Turbocharger Outlet Flex Pipe LEU, MRU

PI0834, Turbocharger Outlet Flex Pipe

(November 2013)

W2085297

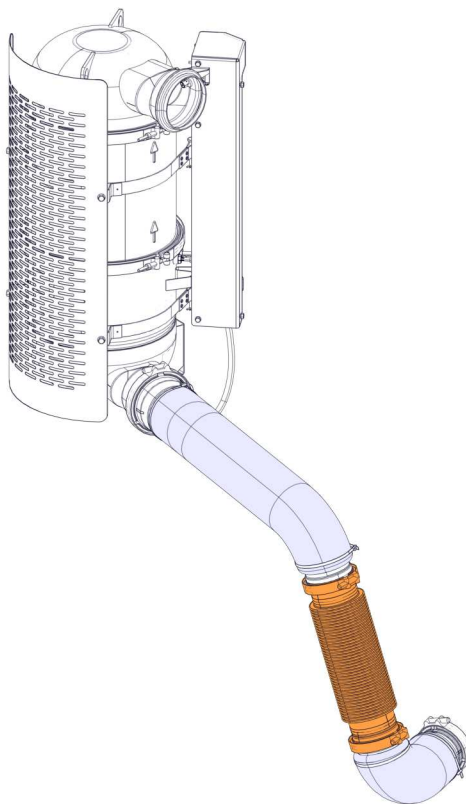
Due to a durability issue with the turbocharger outlet flex pipe, it has been decided to replace the flex pipe on all Mack LEU and MRU vehicles with a MP7 or MP8 engine built between April 1, 2013 and October 13, 2013. Replace flex pipe part number 21959391 with flex pipe part number 21428530.

Note: Flex pipe **MUST** be installed as straight and parallel to the turbocharger outlet pipe and DPF inlet pipe as possible.

Note: Flex pipe should NOT be installed in a curved manor.
